APPEAL SUMMARY

Appeal ID: 27744	Project Address: 7875 NE 14th Pl
Hearing Date: 5/11/22	Appellant Name: Brian Hoeft
Case No.: B-009	Appellant Phone: 5032263617
Appeal Type: Building	Plans Examiner/Inspector: Chanel Horn
Project Type: commercial	Stories: 1 Occupancy: B Construction Type: V-B
Building/Business Name: Covered Dog Run / Oregon Humane Society	Fire Sprinklers: No
Appeal Involves: Erection of a new structure	LUR or Permit Application No.: 22-107783-CO
Plan Submitted Option: pdf [File 1] [File 2] [File 3]	Proposed use: Dog Run

**OREGON
HUMANE
SOCIETY -
BRRC & 1411
TENANT
IMPROVEMENT**

1 ARCHITECTURAL SITE PLAN

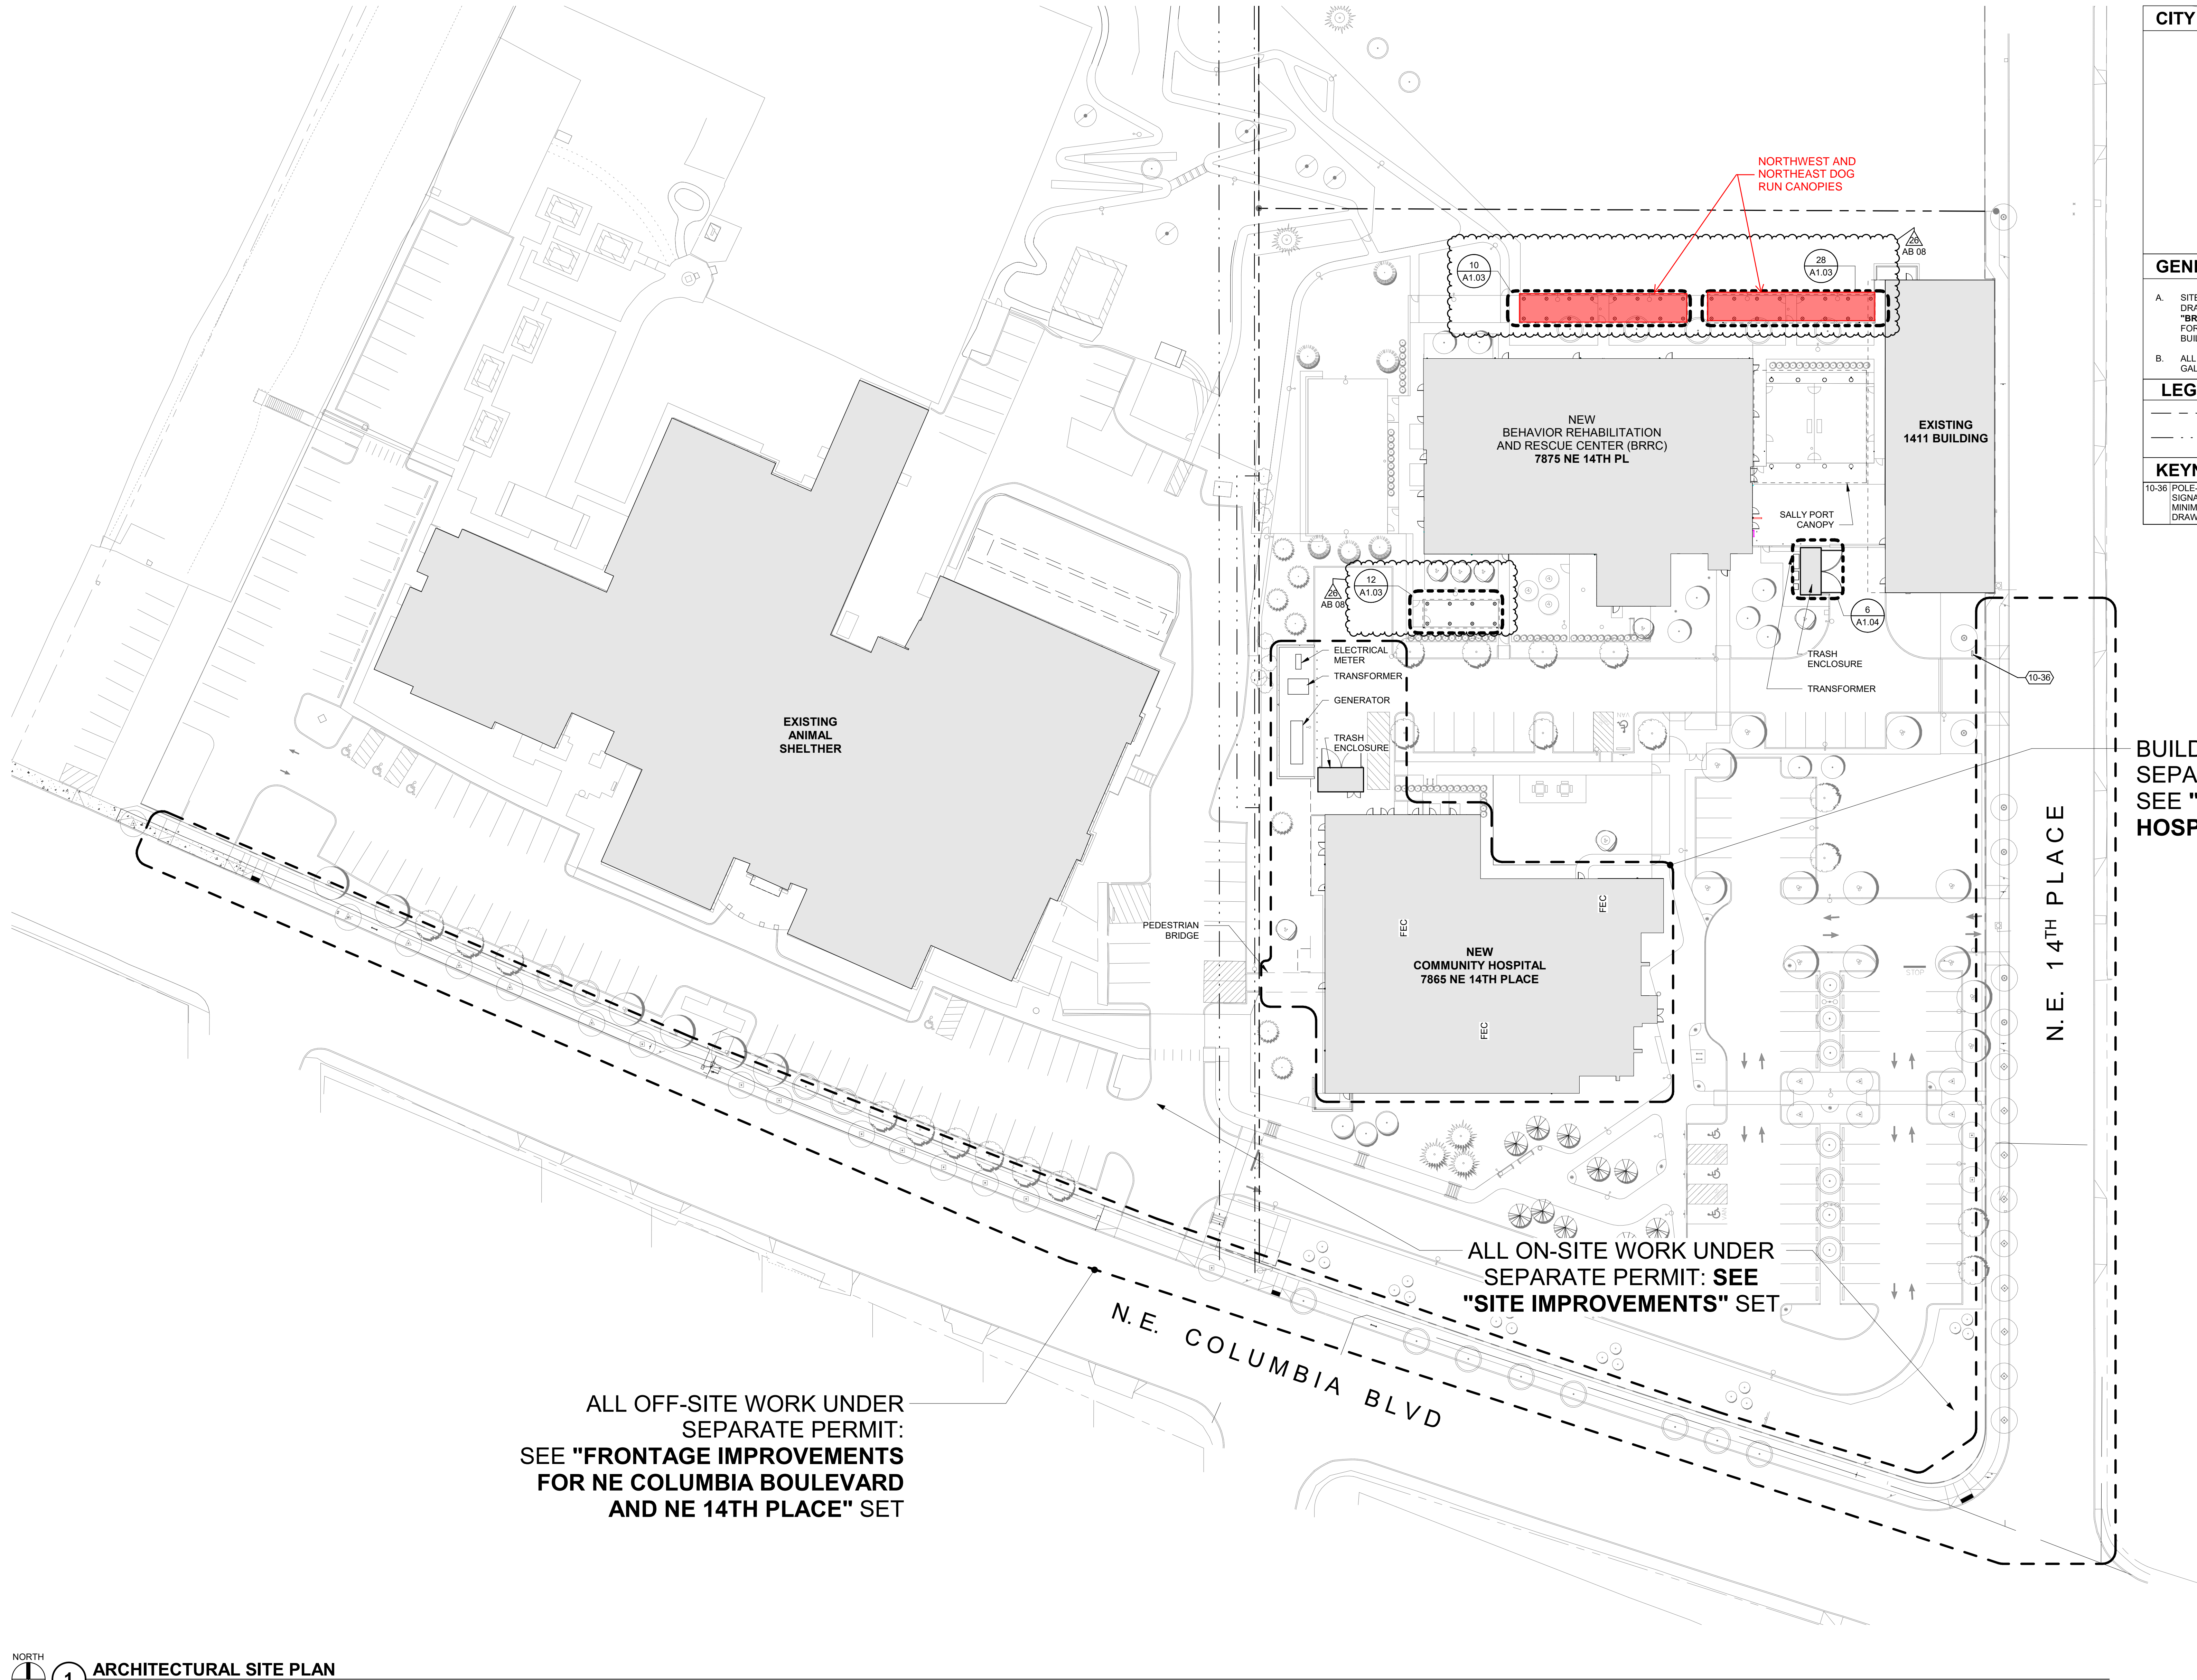
Code Modification or Alternate Requested The intent of the appeal is to forgo the use of fire sprinklers at the northwest and northeast dog run canopies.

Proposed Design We propose to not provide fire sprinklering at the dog run canopies. Per an email from Wendi Colmone, Fire Inspector Specialist with Portland Fire and Rescue, the “dog runs would not need sprinkler coverage for several reasons, one of which being, they are small concrete pads with fully,

non-combustible roofs and chain link fence for walls. This design will not allow enough heat to collect and trigger a sprinkler head if in the off chance something did catch fire.”

Reason for alternative Per the email from Wendi Colmone, “if a sprinkler system was required it would very costly to install a dry valve and system to each individual dog run.” Additionally, these dog runs will contain an animal, a human, and potentially a dog toy. None of these items are readily combustible and no source of flame will be located within these structures.

Code Modification or Alternate Requested The intent of the appeal is to provide a standard fork gate latch at the covered dog run canopies in lieu of a lever handle lockset.

Proposed Design During plan review, it was noted that since the fenced-in dog runs on site will have canopies over them, they are now considered buildings. As such, the fence gates are required to have lever hardware to comply with the code sections listed above. We propose to use standard fork gate latches in lieu of lever hardware.

Reason for alternative All of the areas under consideration are employee work areas and not open to the public. There are other gates and uncovered dog runs on site that will use fork gate latch hardware, so employees will be using this hardware in other areas of the site.

Hi Wendi,
Based from OSSC Sections 503.1.2 and 705.3 the three dog runs clouded in red below are required to provide a sprinkler system as they are being considered as portions of one building with the BRRC and 1411 Buildings. The south dog run has been shown to building code compliance to not require a sprinkler system.
I would recommend they request a [building code appeal](#). They can include the information you provided below in the appeal reasoning. If they have any questions about the process of the building code appeal they may contact me.
Please let me know if you have any questions.

1. Omission of sprinklers in covered dog run: Granted as proposed.

2. Use of a standard fork style gate latch at covered dog run: Granted as proposed.
